NPA/25/39

Title of Proposal: Quinquennial Review

RA(s) or Manual Chapter(s): RA 3521

RA 3521 - Permanent Fixed Wing Aerodrome – Facilities

Figure ► **1** ◀. De-icing / anti-icing facility marking

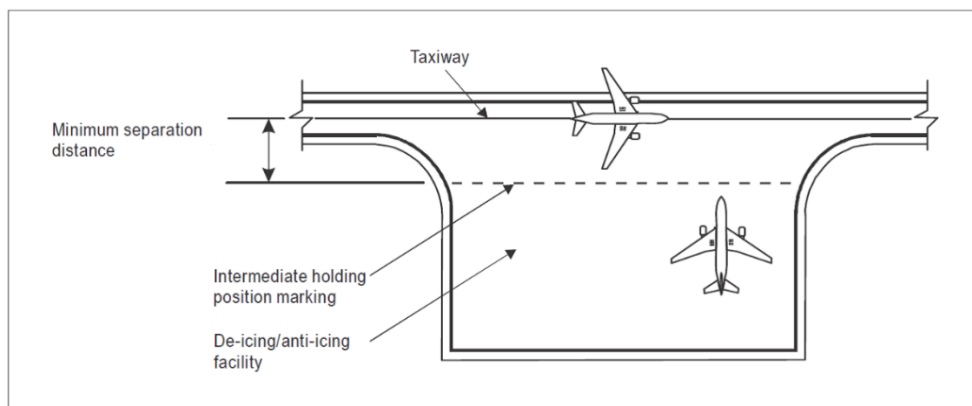
Para 28: Figure number amended.

Figure 1: Title number amended for accuracy.
